ADDENDUM NO. 1

TO: All Holders of Plans and Contract
Documents for the Gamble Road Bridge
No. 2390003 Replacement, BRO-B068(014)
Moniteau County, Missouri

ISSUED: November 12, 2019

TYPE A CRASHWORTHY END TERMINAL
N.T.S.

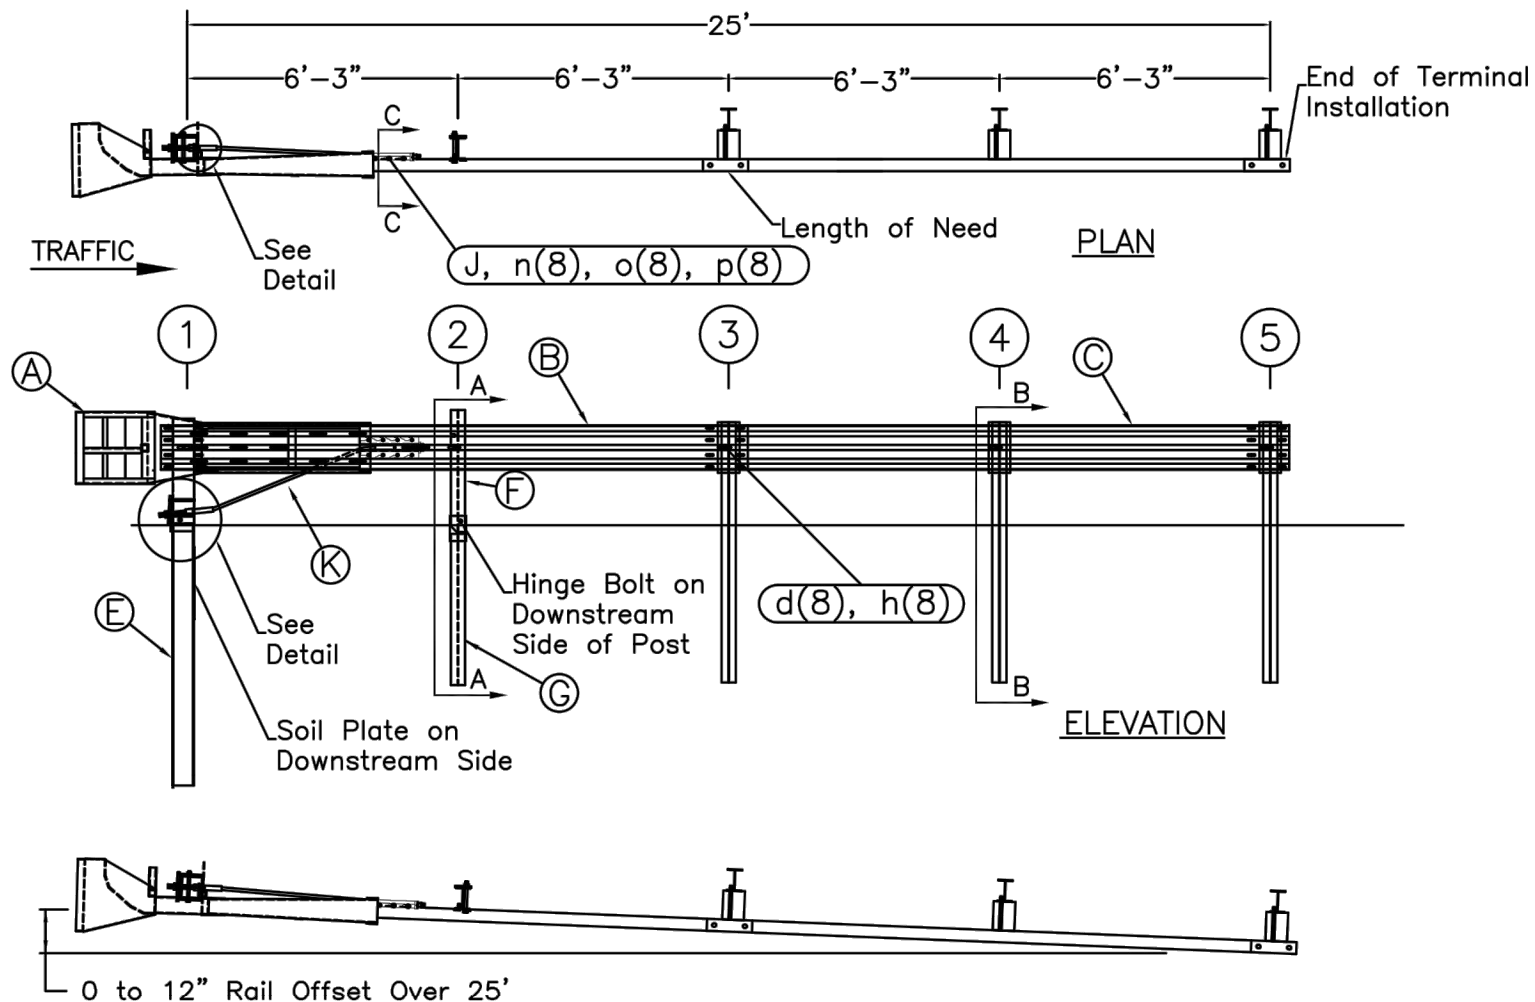
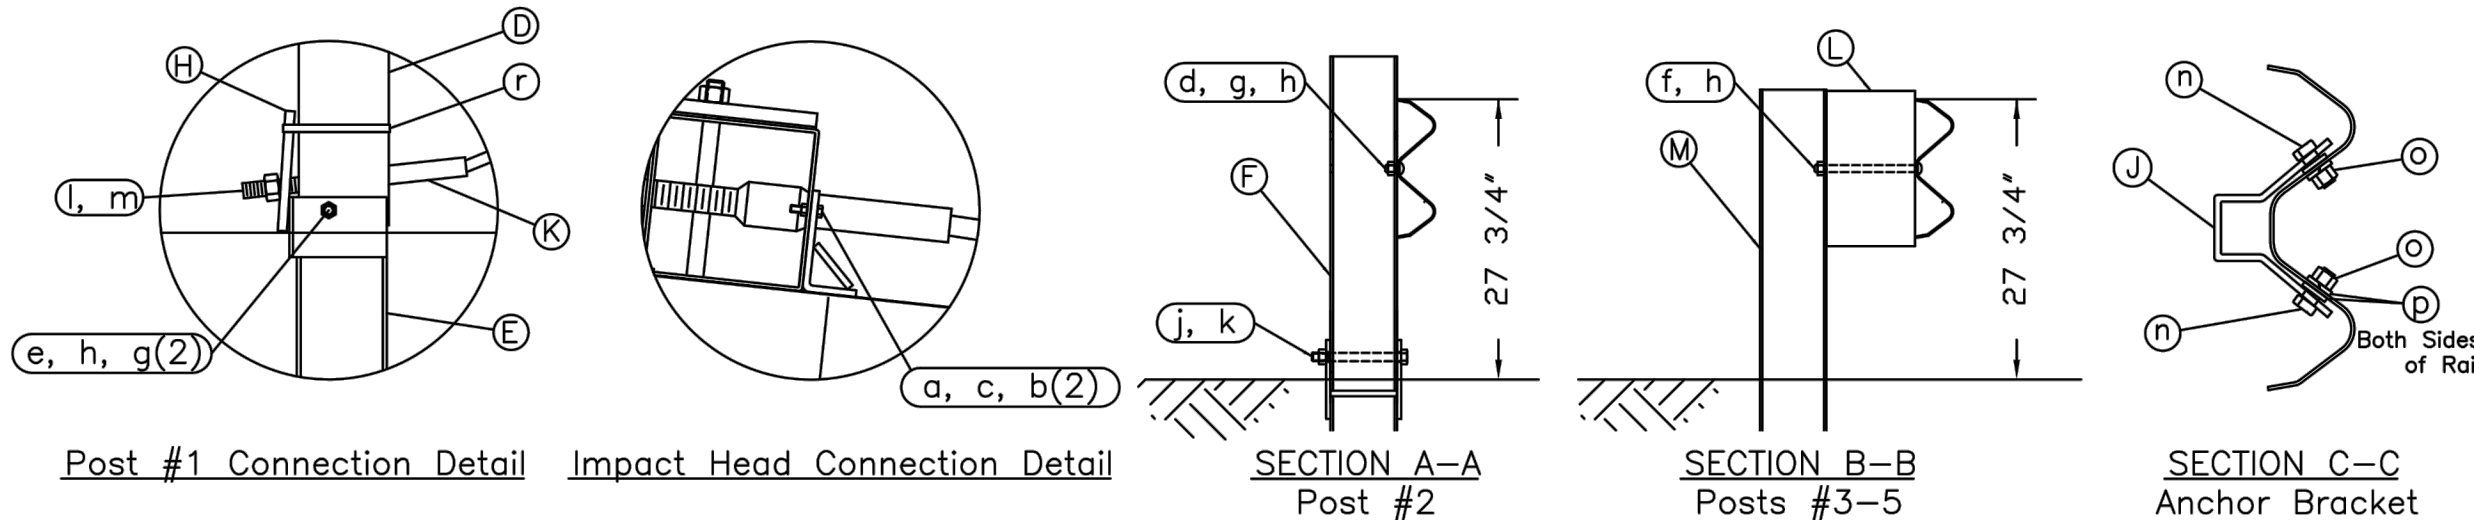
- 1) Plan Sheet 17, replace MSKT-SP-MGS with NCHRP 350 SKT-SP TL2 for the End Terminal to eliminate midspan splice.

SKT END SECTION IS SHOWN FOR ILLUSTRATIVE PURPOSES, OTHER SIMILAR PRODUCTS ARE ACCEPTABLE.

SKT-SP
Sequential Kinking Terminal
Test Level -2
Steel Post System
Drawing Name: SKT-SP-TL2-S
Scale: None
Rev: 0
